CBER (b) (6) CMC/Facility BLA Review Memorandum

BLA STN 125869/0

Influenza Vaccine, mRNA (mRNA-1010, MFLUSIVA)

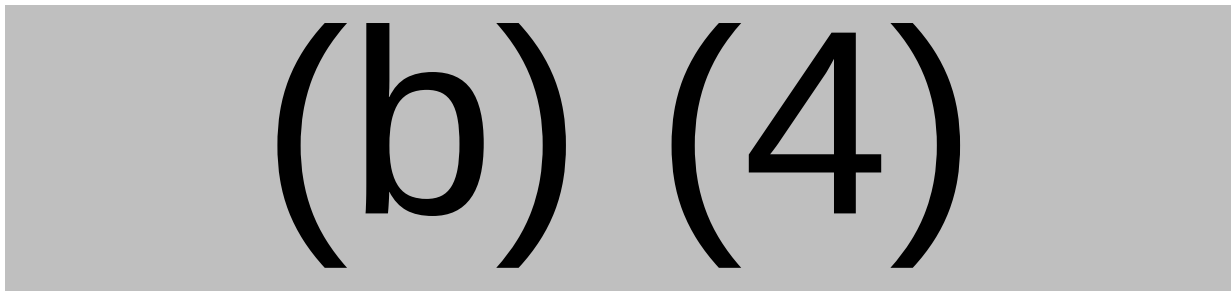
Reviewer's comment: *The firm provided summaries of equipment qualifications and a list of major process equipment used for the manufacture of mRNA-1010 as compared to previously approved vaccines, mRNA-1345 and mRNA-1283 in amendment STN 125869/0.14 (eCTD 0015). The amendment was reviewed and appears acceptable. No major changes were made to major equipment qualifications or equipment cleaning.*
